## Mechanical Electrical Addendum No. 01

**EXP Project:** ALL-23010629-A0 HWDSB Glendale

PROJECT:  
Boiler Renovations

Glendale  
Secondary  
School

M2.0

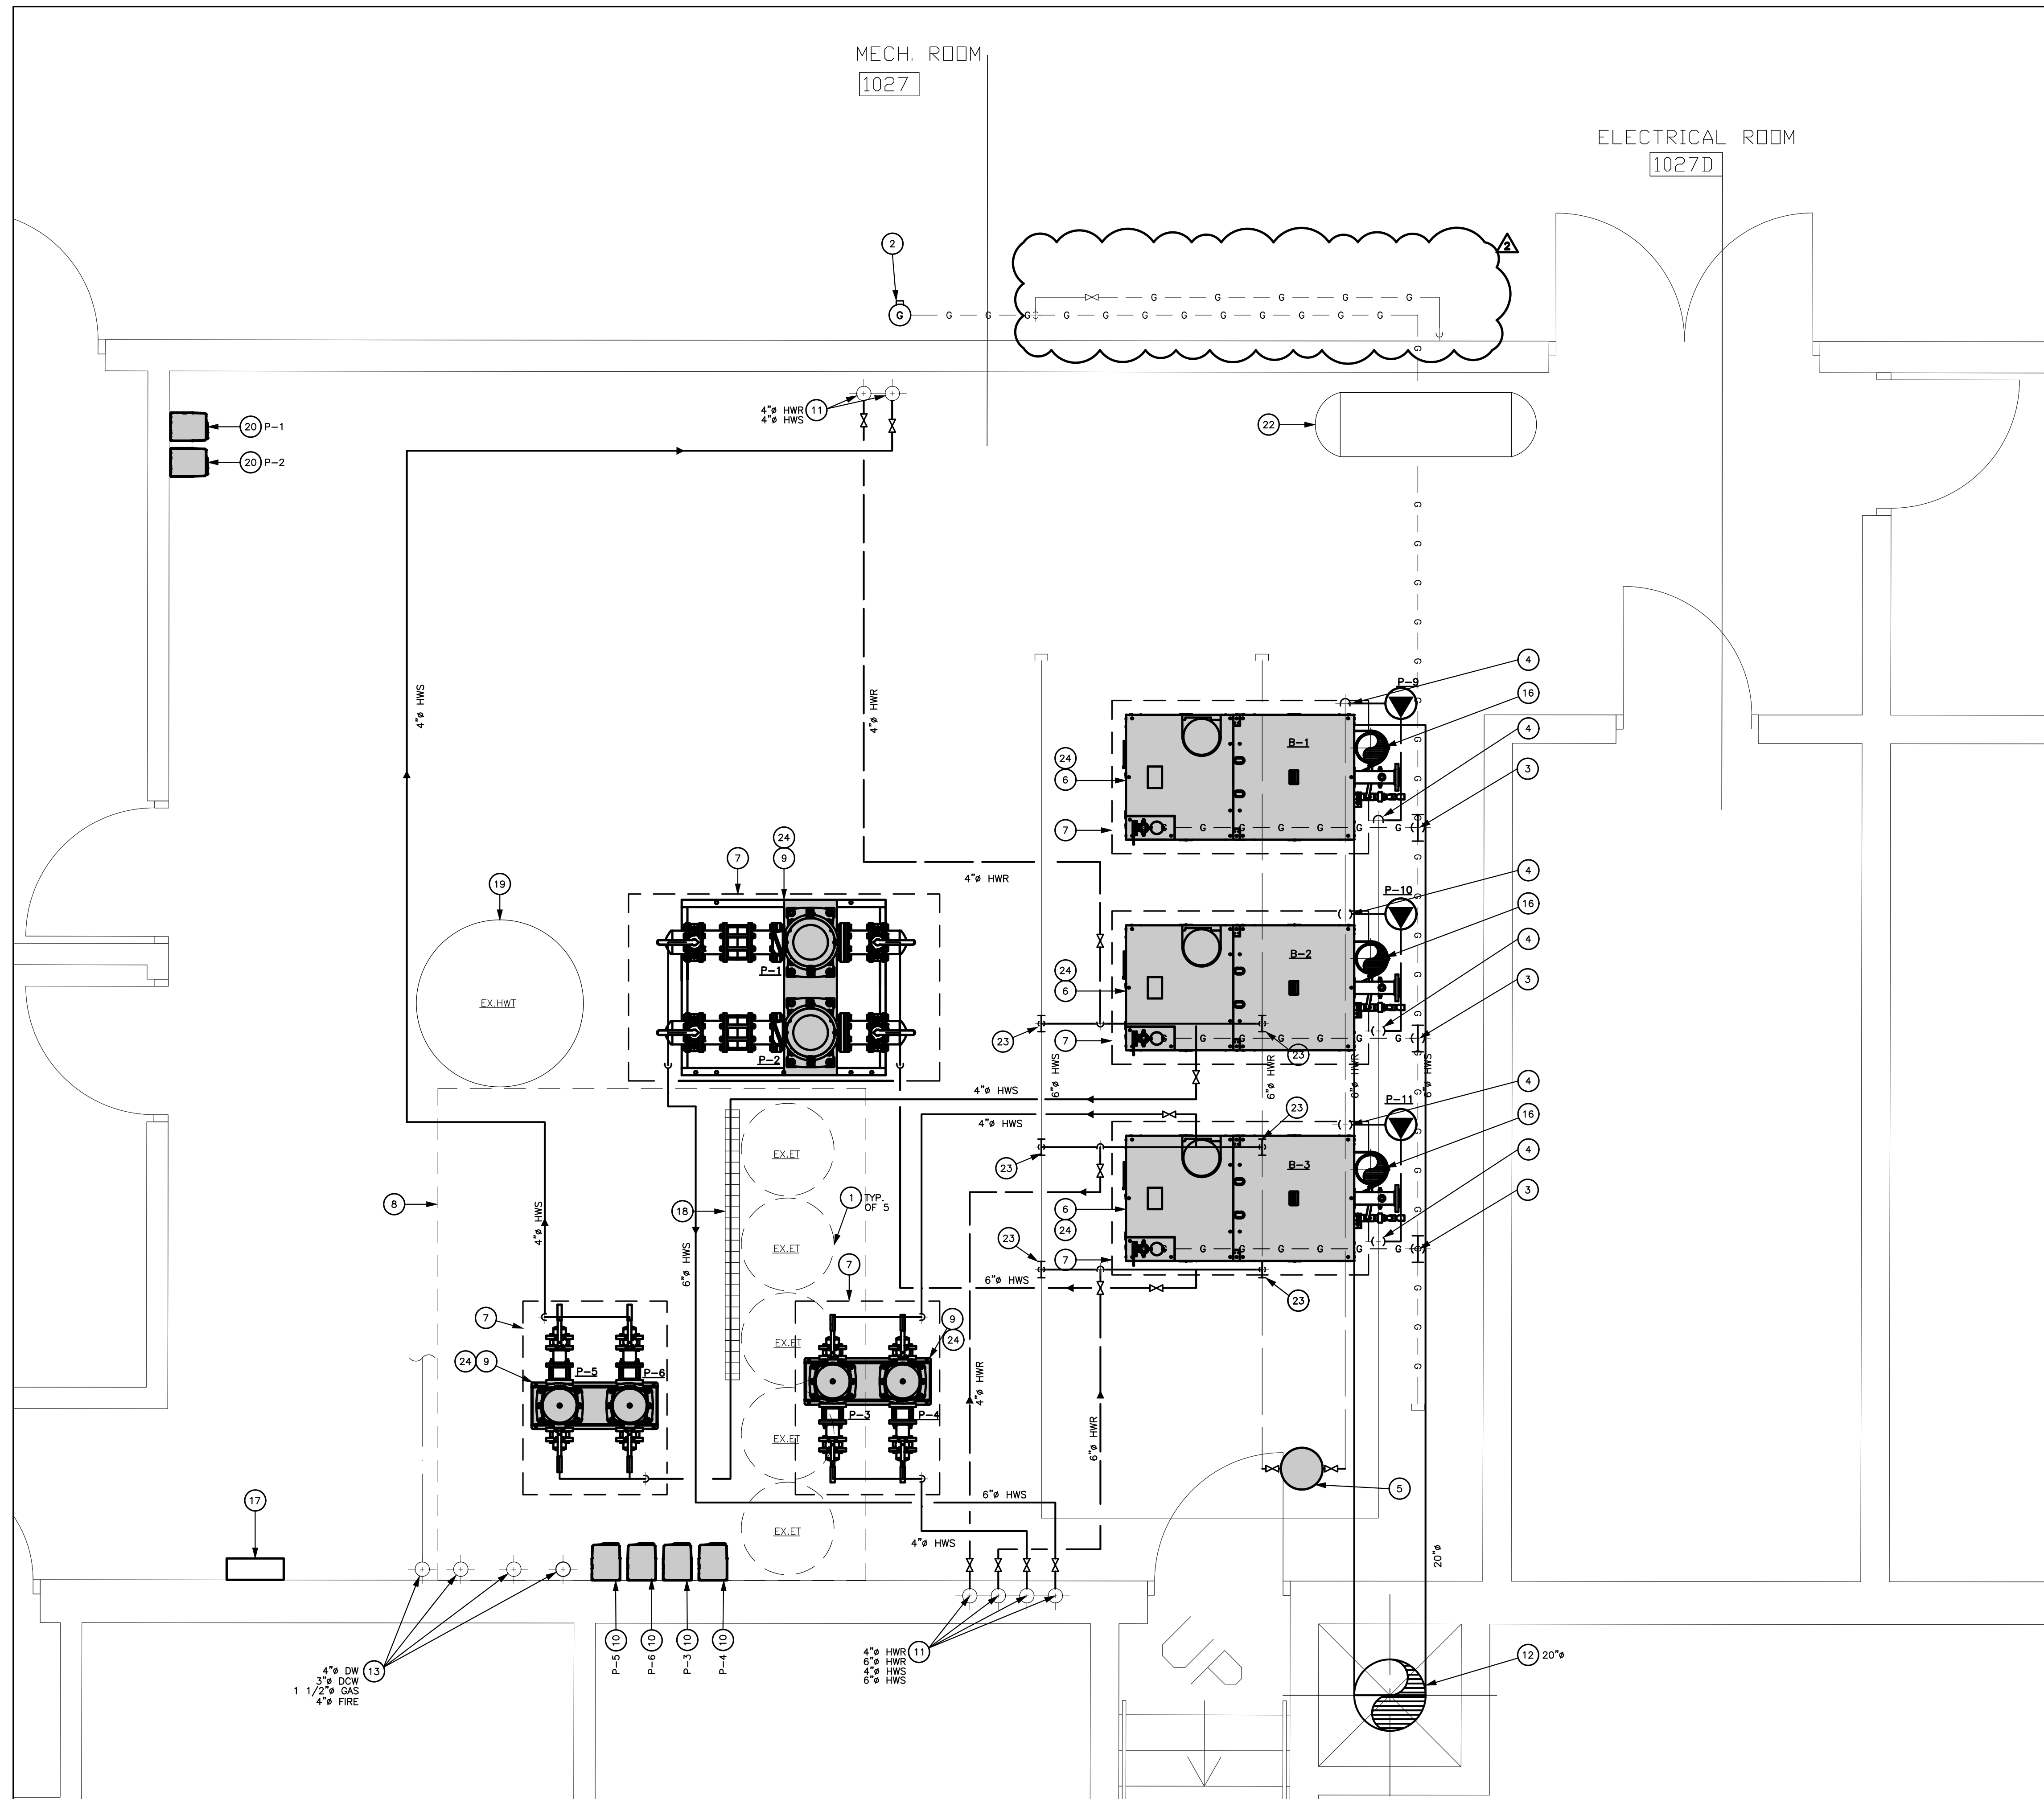
Drawing M2.0 note 14 references drawings M0.2 & M2.3 for continuation of the gas line, however M0.2 is a spec drawing, and M2.3 is not part of the package. Can we get clarification on this note?

Additionally, on the same drawings note 15 mentions a new ERV and RTU's, however no drawings show this equipment, and it is not on the schedule drawing either. Is this work to be included? If so can we get the schedule of this equipment?

D. This is not within the project scope of work. Refer to updated Sheet M2.0 provided with this addendum.

E1.0

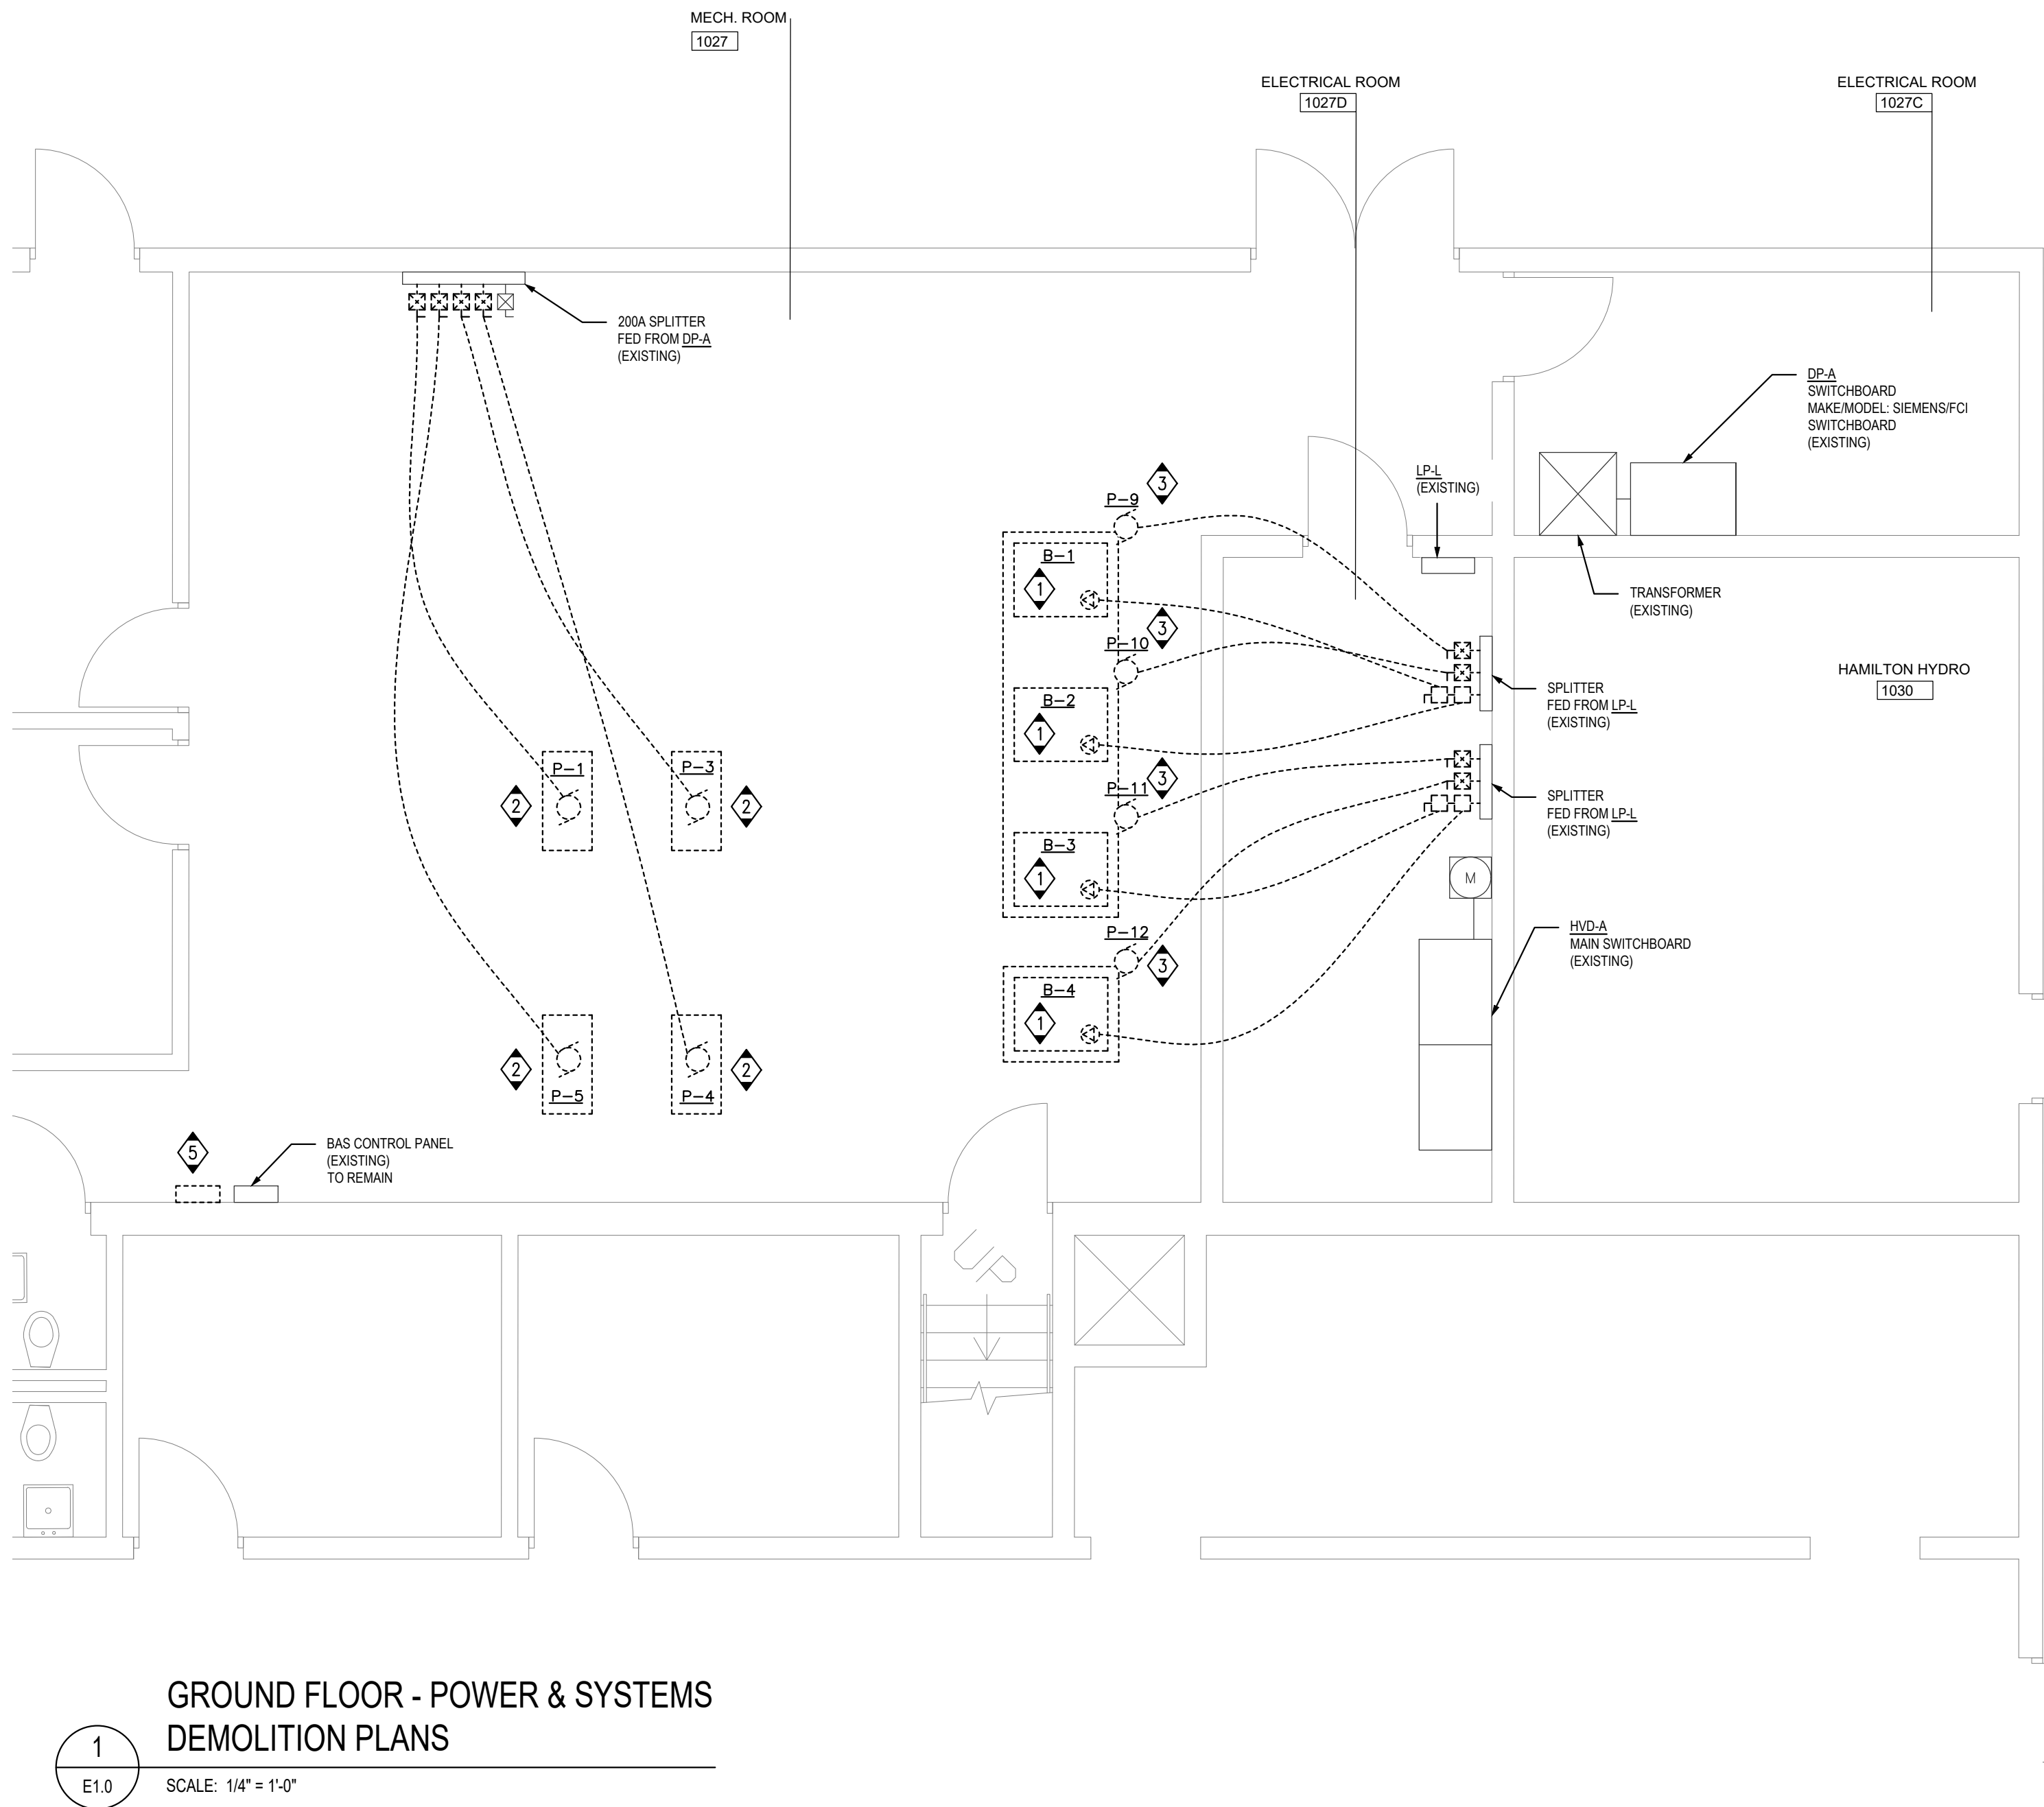
Drawing E1.0 Drawing Note 4 References removal of cooling unit fed from Panel (PNL-U), however it is not on drawing. Please clarify.

D. Disregard Note 4. Only refer to notes relevant to the scope of work
